7 Oxford
Cherry Chase Village H.D.

MONTGOMERY COUNTY HISTORIC PRESERVATION COMMISSION
STAFF REPORT

Address:	7 Oxford Street, Chevy Chase	Meeting Date:	2/23/11
Resource:	Contributing Resource Chevy Chase Village Historic District	Report Date:	2/16/11
Applicant:	Michael and Yael Summerfield (Don Marette, Architect)	Public Notice:	2/9/11
Review:	HAWP	Tax Credit:	None
Case Number:	35/13-11J	Staff:	Anne Fothergill

PROPOSAL: Rear addition construction

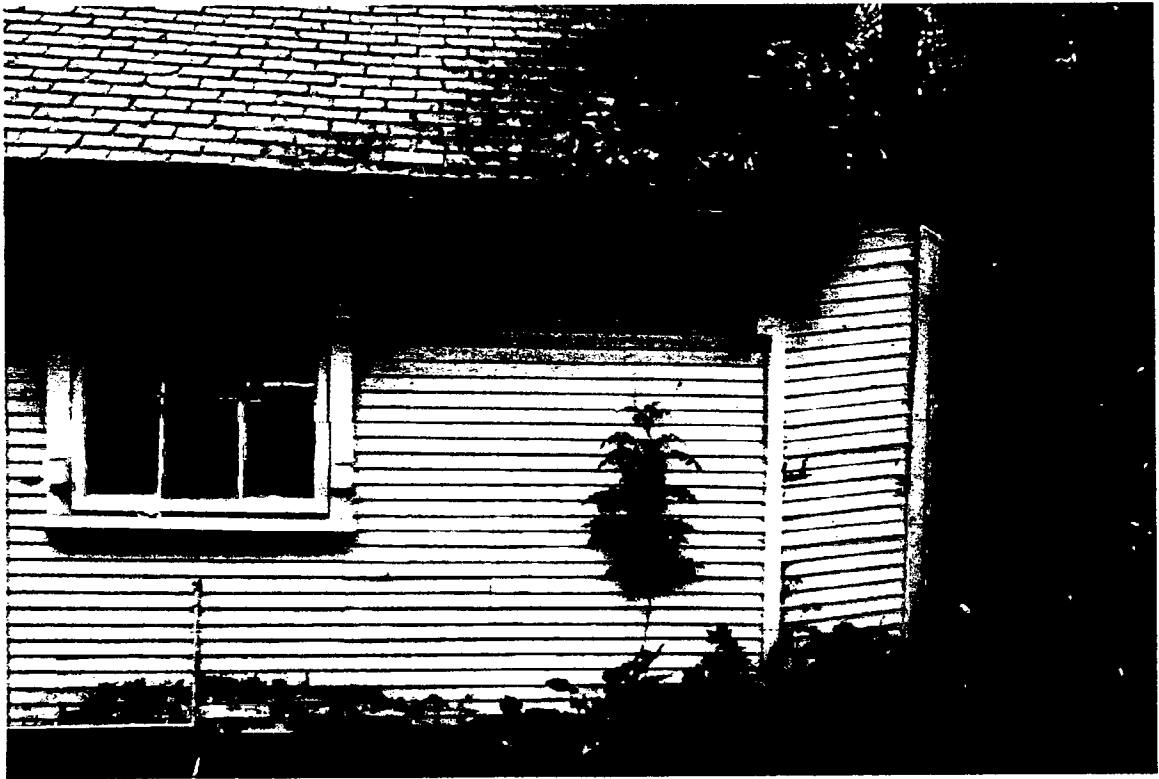
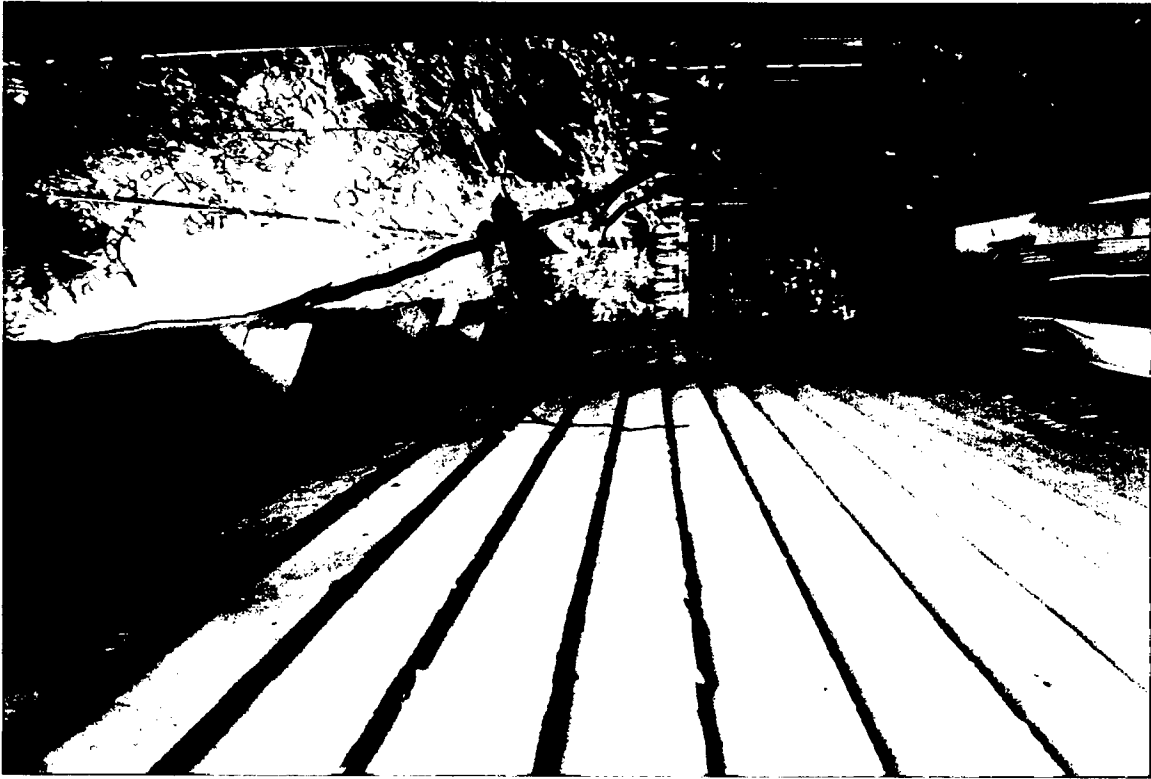
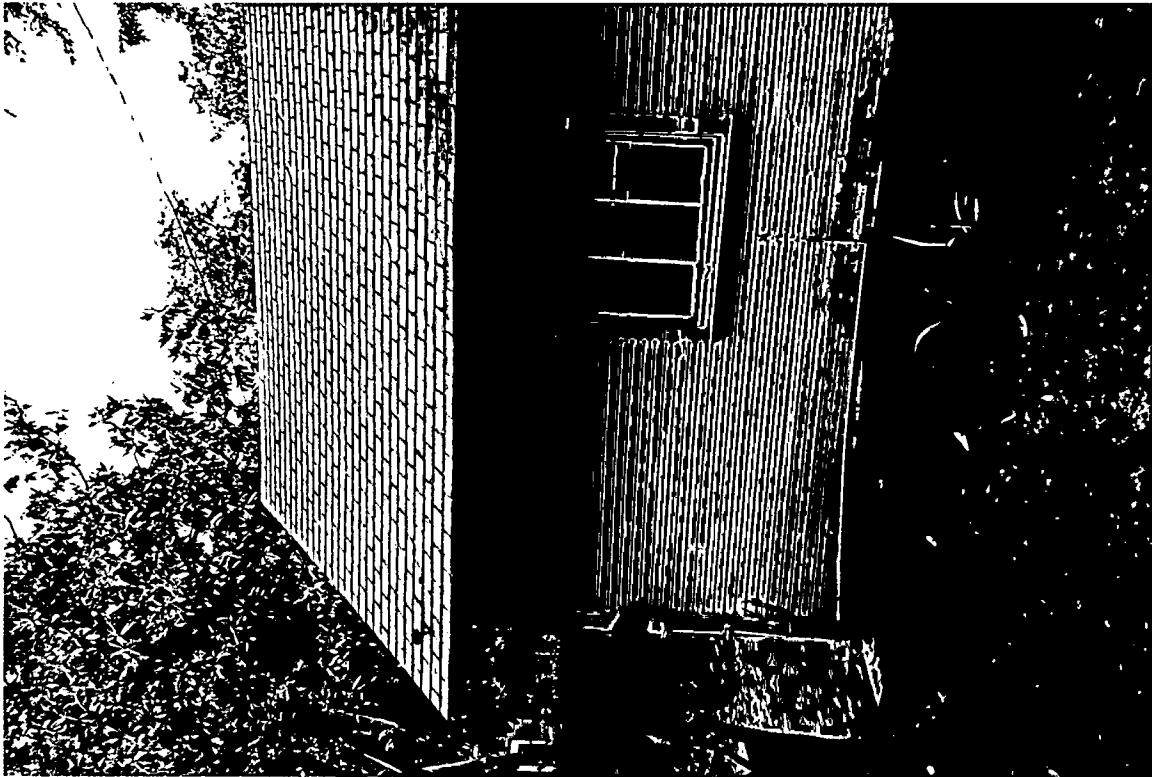
Yes, I need additional information. Please send a written description of the affected rot/insect damaged area and hopefully photos that show it. Can you get to the back of the garage to take photos or maybe get some from the inside? Please re-send the site plan with the garage bubbled out and showing the area that will be removed. Please describe the workscope—how you will remove the damaged area and then put the salvaged siding back on the original rear.

While performing the current permitted work at 7 Oxford Street we discovered damage to the Circa 1917 garage from dry-rot and carpenter ants. The problem area is at the rear 2' extension added Circa 1965. The owners wish to restore the garage to its original dimensions by removing infested area, closing the rear wall and re-using existing siding to restore.

The owners of 7 Oxford have discovered structural damage to a rear non-historic section of the garage and they are proposing to remove this small extension of the garage and rebuild the back wall with its original form and with salvaged siding. Staff recommends approval.

7 OXFORD STREET

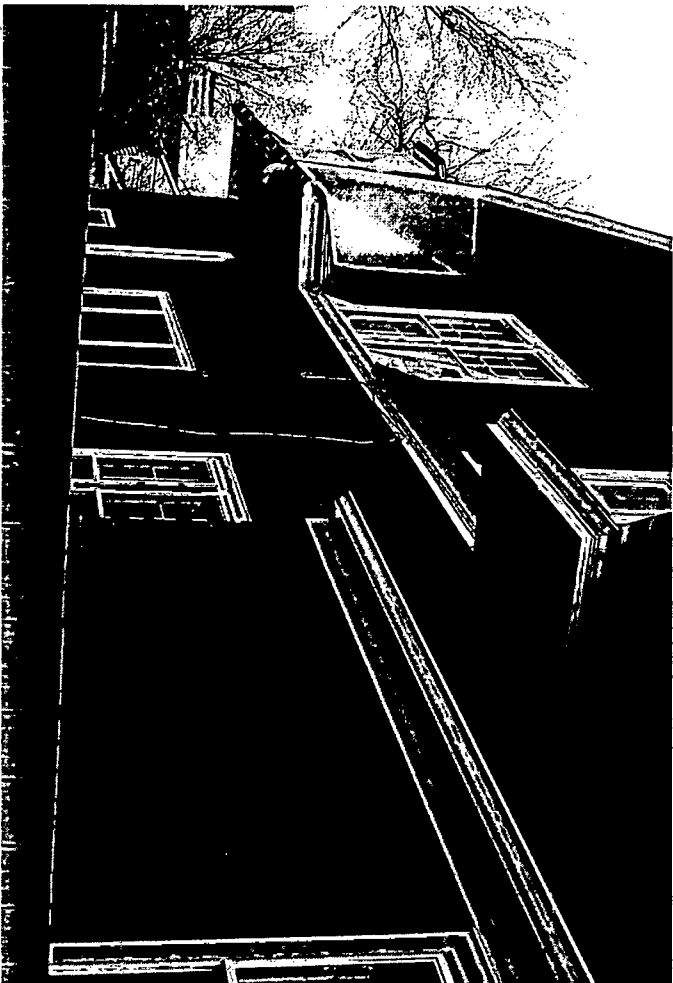
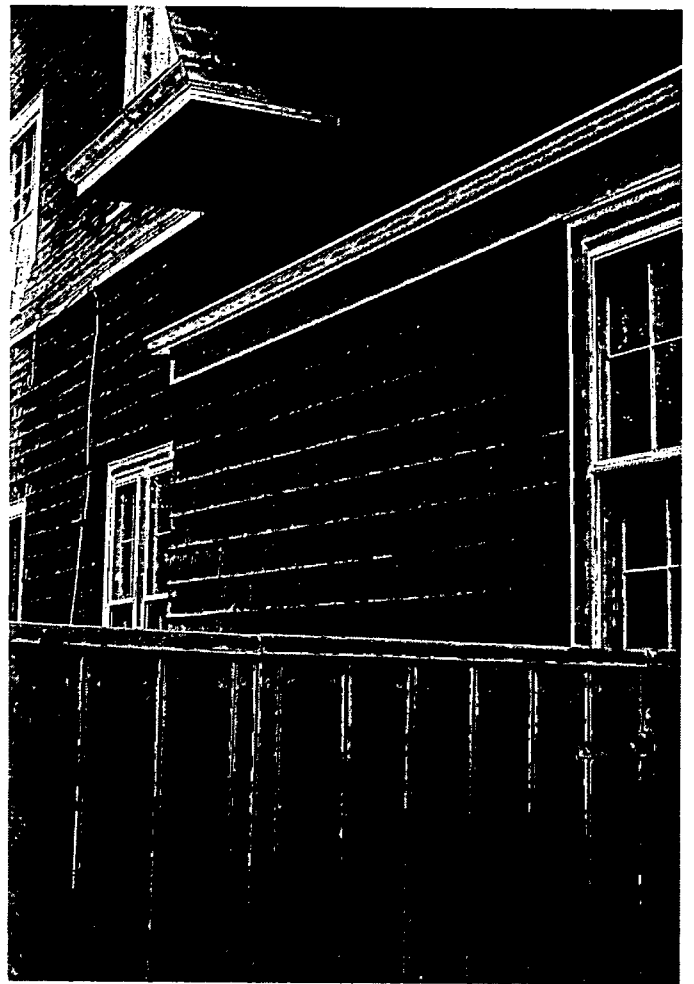
small, compatibly-designed bays on side elevations when they have a minimal impact on the historic resource. The proposed 24" box bay will be 16" narrower than the existing bay and will extend out less than the existing front porch's width. The reuse of two original windows in the new addition is commendable.
